MEETING OF THE PLANNING COMMITTEE

Re: 135 Wildwood Avenue Structure Setback Variances (impervious percentage pending)

Re: 315 Wildwood Avenue Building Height Variance

CERTIFICATE OF SURVEY

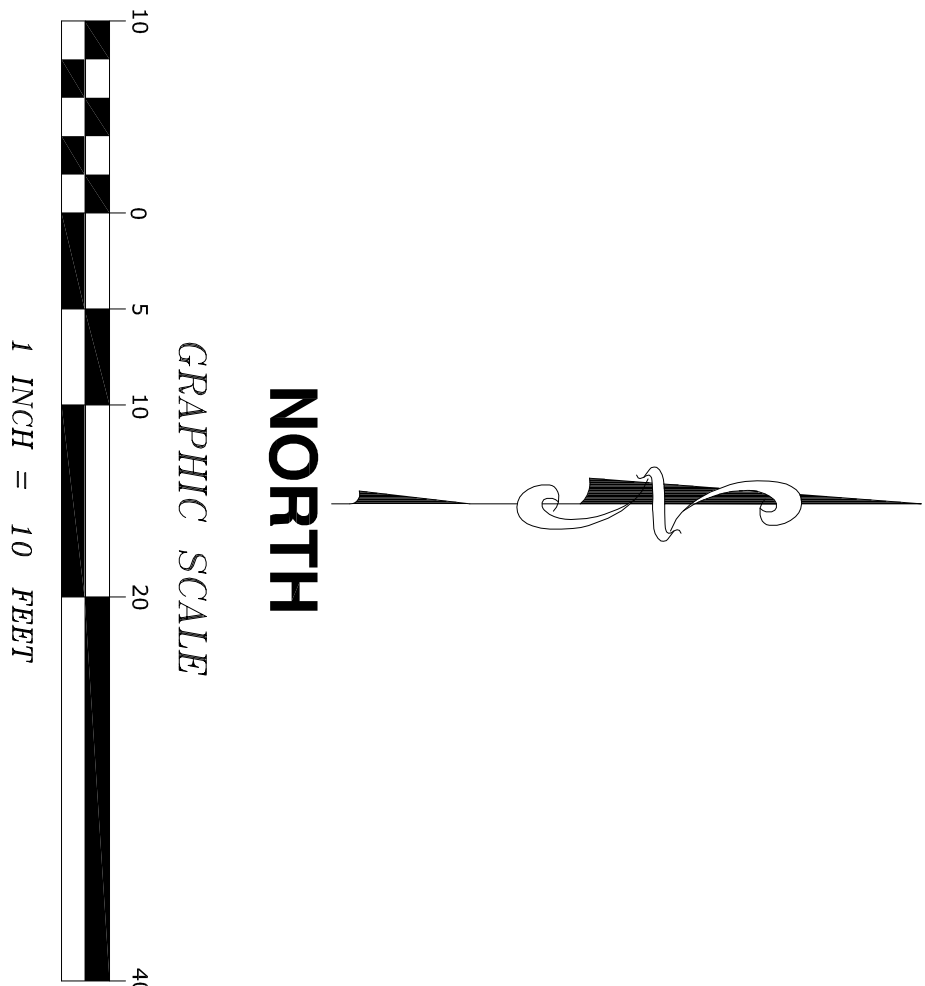
The Hapkas have submitted elevations for garage, as well as a survey showing existing and proposed conditions (see below and attached).

As with the other application on the Planning Commission’s agenda, this is a simple request, as the proposed garage can be seen as meeting the general intent of the ordinance (accessory structure on a lot with a single-family home) and generally in harmony with the comprehensive plan (accessory use to the single-family home).

This application comes down to the Planning Commission’s, and ultimately the City Council’s, interpretation of practical difficulty, insofar as it relates to the reasonableness of the proposal and the character of the neighborhood. The uniqueness of the property is considered the narrow lot, not subdivided by the applicant, with a home that has long existed in its current location (limiting the buildable area options), not chosen by the applicant.

As mentioned in the opening paragraphs, this is not to be considered an expansion of the structure, but rather a new build with setback variances. Keep in mind that the applicants, should they be denied, may still rebuild the existing garage in the same location with the same footprint. I believe it has been decided that the height could not be increased, as that is considered to be an expansion in state law, even if the structure height is below ordinance requirements (NOTE: I am unaware of what the ordinance amendment is that is being heard at this meeting and whether that will affect or negate the following point). However, that doesn't mean that, based on the ordinance definition of height, a different design with a different "massing" as viewed from the road is not possible. A mansard roof to, in this case, match the house design, *could* allow the same measured height, as could flat, butterfly, gambrel, jerkinhead, skillion, saltbox, and other designs. (One of the reasons stated by the applicant for a larger footprint is to allow a larger face area of the street-facing wall to allow somewhat standard, 8-foot high garage doors – see pictures of existing above.) Staff does not anticipate such a change in design, but it is worth keeping in mind that different designs with the same height, that greatly change the structure's appearance, are possible. I have heard discussion and opinions from land use attorneys related to this statute, but because they don't work for Birchwood and it was decided that any research done with outside attorneys – even without presentation as a written opinion rendered - may put the City in grave legal peril, I cannot share those discussions.

CERTIFICATE OF SURVEY

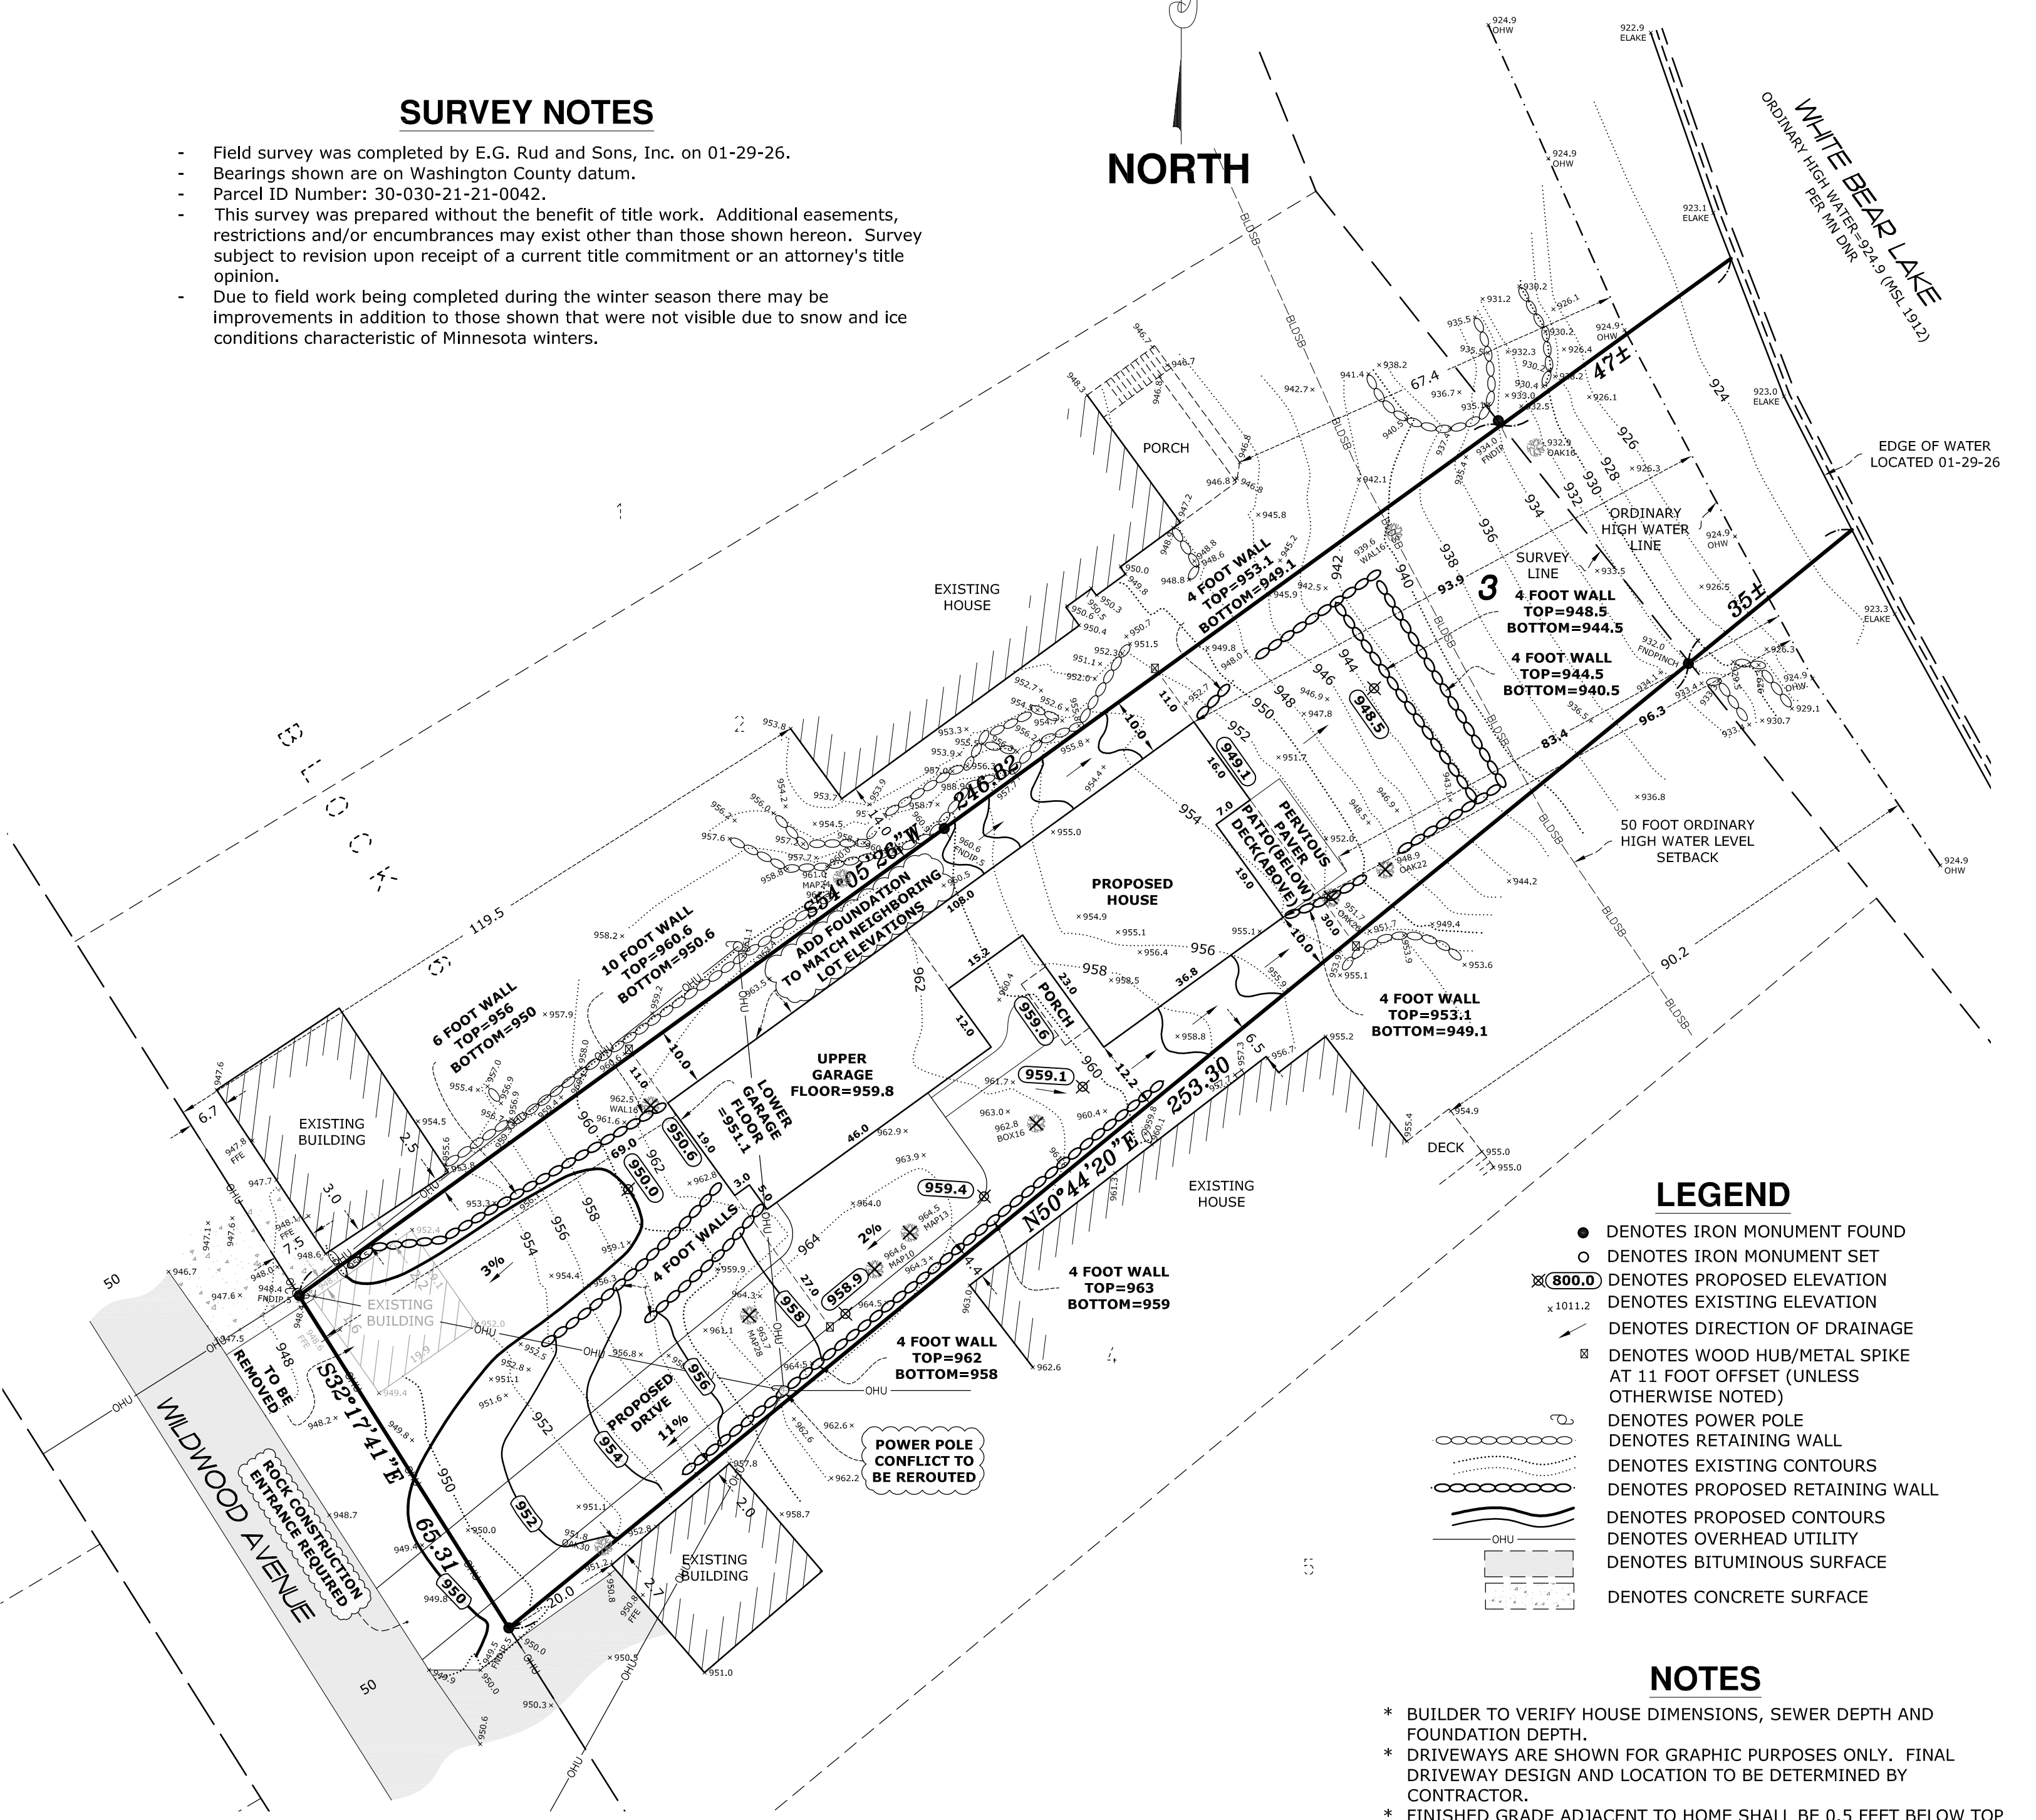
Mr. Welle has submitted elevations for the house, as well as a survey showing existing and proposed conditions (see attached). As noted during the concept review of this project, the main points of discussion, or things to keep in mind, are the following:

- The maximum height of the structure is 39.0’. The highest roof is set back 6’ further from the lake than the forward-most portion of the house, which appears to be near the 35-foot maximum.
- The proposed house is significantly behind the required setback from the Ordinary High Water Line; the closest point of the house is 93.9’ from the OHWL, while a proposed deck is 83.4’ from the line. The ordinance requires a 50-foot setback from the OHWL.

- The proposed house is roughly in line with the setbacks of the adjacent homes (see survey); the existing home at 309 Wildwood Avenue is closer to the lake, while 321 Wildwood Avenue is further from the lake than this proposed house; a line between those two immediate neighbors would be the approximate building line of the house at 315 Wildwood Avenue.

- The existing grades/contours are shown on the survey, and are the basis for the practical difficulty on the property.
- Mr. Welle will describe the type of construction, the ceiling heights, joist design, etc. at the meeting.

- Other items that will be considered from the survey and proposed construction are as follows:
 - The proposed impervious surface on the property is below 30% but above 25%, which will require mitigation by means approved by the City Engineer.

- The proposed retaining walls on the site include walls higher than 4' leading to the garage; retaining walls that are "part of a building" may be higher than 4' (would still require engineering) without the need for a variance. Staff will work with the applicant to determine the design and the appropriate entitlements.

- The proposed deck must maintain the required side-yard setback of 10'; the conceptual design shows the corner of the house to be 10.0' and the deck to be slightly closer to the angled lot line.

REAR ELEVATION

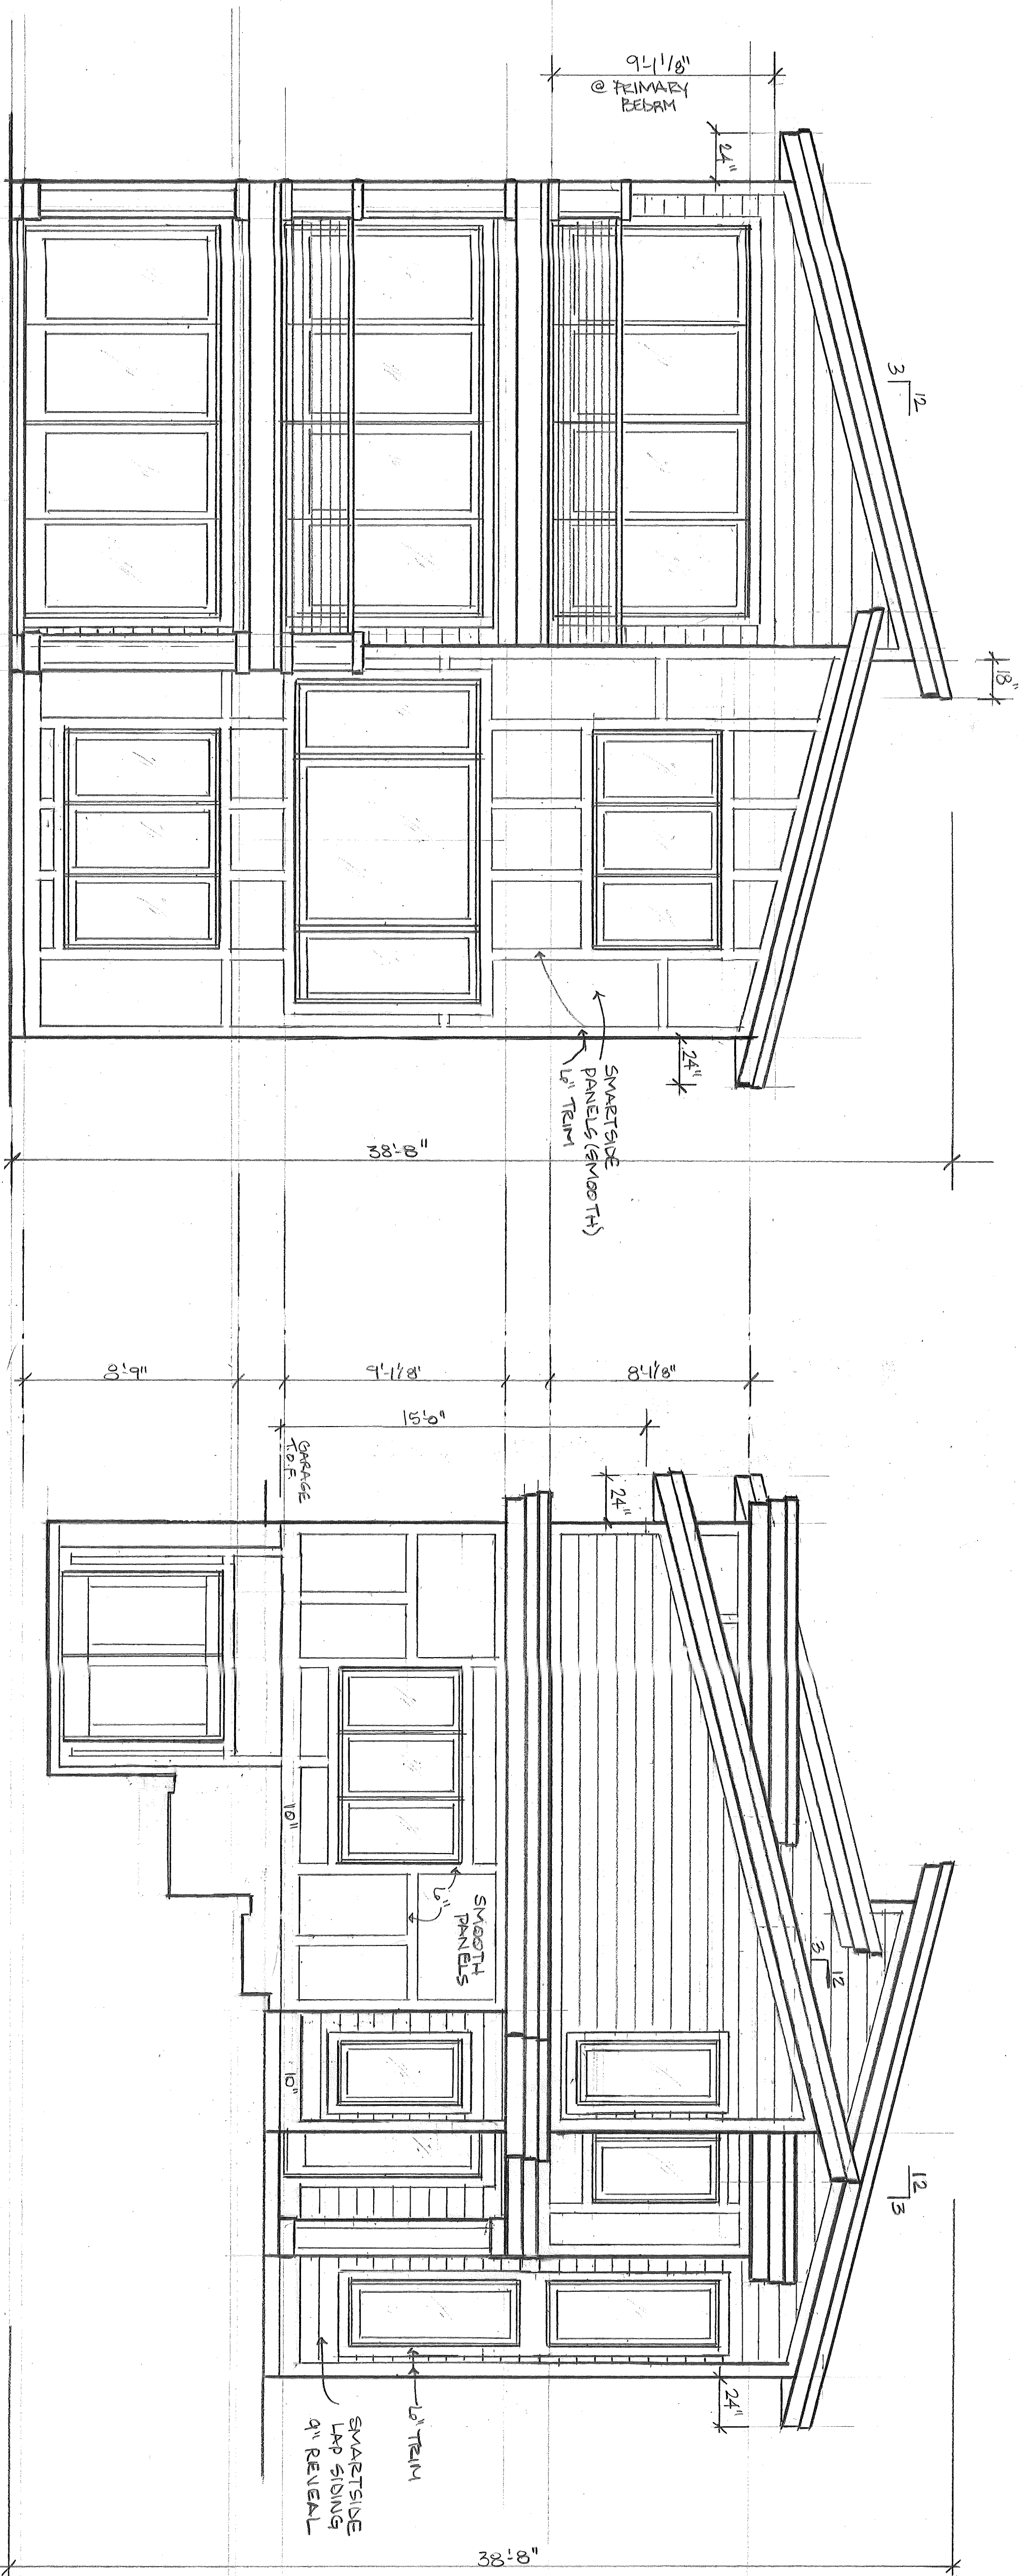
This is a simple request, as the proposed house can be seen as meeting the general intent of the ordinance (average height is well below the maximum allowed, and tallest point is a minimal part of the structure as viewed from the lake side), and generally in harmony with the comprehensive plan (single-family home which happens to be proposed on a narrow, sloped, buildable lake lot).

As mentioned earlier, the average height of the structure will be well below that allowed by ordinance (30'), but the peak height is 4' taller than the maximum allowed. The way the ordinance is written and structure heights are measured, other than flat-roof homes (which are allowed to be 32'), it is unlikely that Birchwood Village will ever have a house – at least on properties with anything more than minimal grade changes - that approaches the allowable average height yet stays within the maximum height limitations. Perhaps that was the goal when the ordinance was written.
